October 03, 2018

Re: Comments to CARB Proposed 2018 Improvements to Vapor Recovery Nozzle and Vehicle Fill Pipe Specifications

ISO 13331 Figure 5 cross-section X

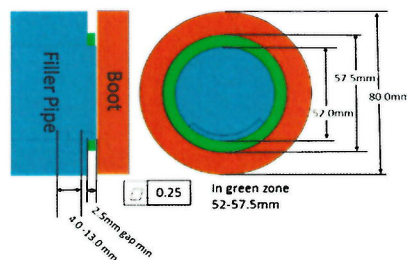
During the transitional period, the ISO 13331 current version will be still utilized. There needs to be a clarification on the 2.5mm reference in the ISO 13331 Figure 5 cross-section X. Today there are several interpretations of this and a consensus needs remedied. The Committee would prefer to have the clearance defined similar to the method 1 version of J1140 being drafted at this time. The Proposed SAE J1140 Filler Pipe Face Clearance figure is added below to show the zone for method 1(current SAE J1140/ ISO 13331) and method 2/3 updated clearances referencing 12mm of encroached clearance.

Current Automotive Interpretation

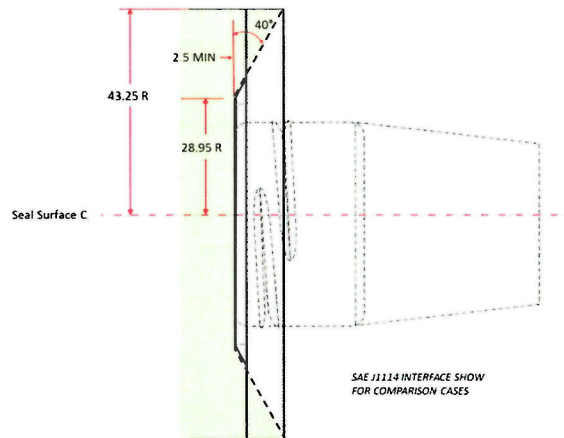
Proposed SAE J1140 Filler Pipe Face Clearance. (2.5mm today called out as method 1 with methods 2/3 entailing further clearance equivalent to the new addendums)

SAE proposes replacing figure A with figure, "Proposed SAE J1140 Filler Pipe Face Clearance"

Figure A:

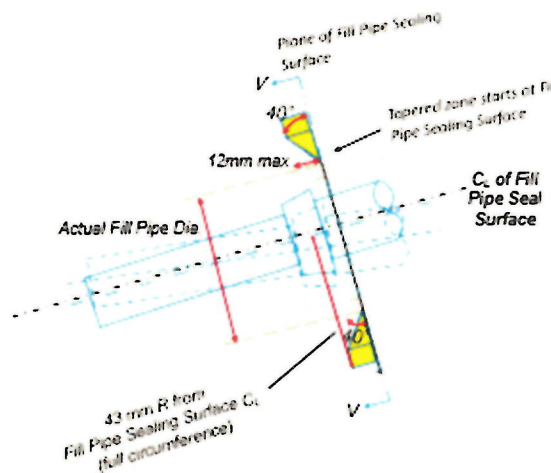
- Figure A needs clarity on the definition of the zone.
 - With the current figure if tapered zone starts at, for example 52.0mm seal surface, the 40° clearance zone would end before reaching the 86mm outer range, and is not defined. See Figure A update below

Figure A updated to show concern

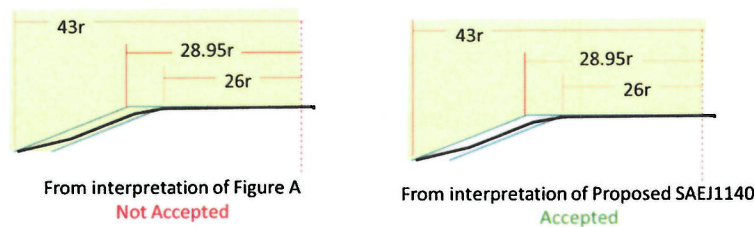
- Figure A with floating Pipe diameter can lead to additional concerns for interpretation of zone
 - Example: when a smaller than 57.9mm seal surface is used as shown in the illustrations below,
